Title:: Tool and Notation for Capturing and Communicating Enterprise and Technology Structures, Processes, Strategies, and Concepts

Application Number: 10/602,566

- Response to response claim 19 rejection on Pages 2-3 of the Office Action:

remarks figure 1: from Nochur

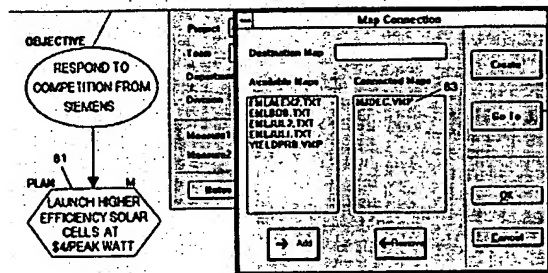
- b. Most modeling tools have objects or entities with attributes as does Nochur. Nochur uses traditional flowcharting symbols for the entity and pop-ups for the attributes. Nochur doesn't claim or have any invention in this area. My invention is in the way the information is presented. The difference in presentation is clear in remarks Figures 1&2 below. My claims 1 and 20 attempt to describe the uniqueness.

- Response to rejection of claim 14 on Pages 10-11 of the Office Action:
  1. The Oracle Component icon in remarks figure 2 is an example of claim 14. Michelle's comment is suggesting that Nochor line adornments such as the arrow head in remarks figure 1 above are the equivalent of claim 14. This must be a typo. Claim 14 talks about an element of my claim 1 shape. Nochor's relationship lines are not pertinent.

- Response to rejection of claim 15 on Page 11 of the Office Action:
  1. The M indicator in Nochor indicates there is an attached map. It does not indicate that the object is plural or a collection. For example in remarks figure 1 above, the M on the lower shape does not indicate that "LAUNCH EFFICIENCY SOLAR CELLS AT \$4/PER PEAK WATT" is plural. It says there is a Map pop-up.

remarks figure 2: from Sewell

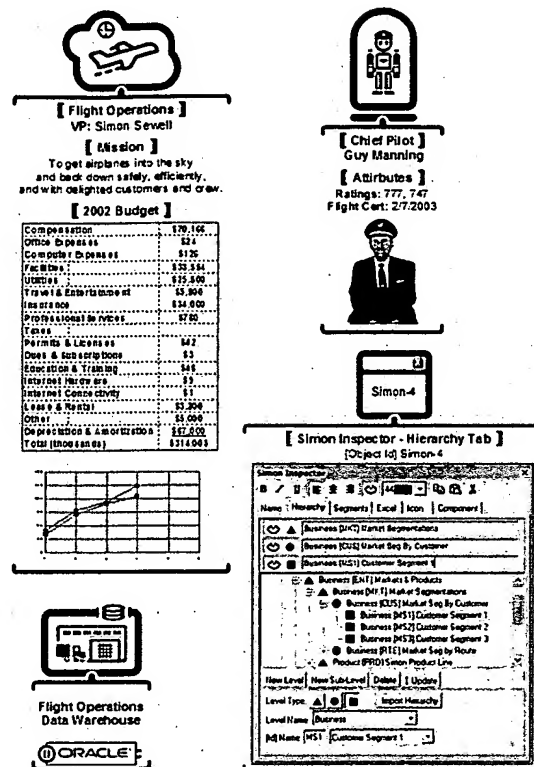
- h. Nochur pop-ups cannot contain graphics as required by my claim 20. Notice the picture of the pilot in remarks figure 2.
- i. Nochur shapes are not **predefined** with **predefined meanings** as required by my claim 1.

- j. Nochur either does not have either **predefined icons** or **predefined adornments**. In Michelle's arguments, she uses the same icon to for both. Nochur might have one (debatable) but it surely doesn't have two or more. Notice the clock and the pilot icon in remarks figure 2. Also, Michelle mistakenly considers a letter M adornment as an icon. One is text and the other is a graphic.
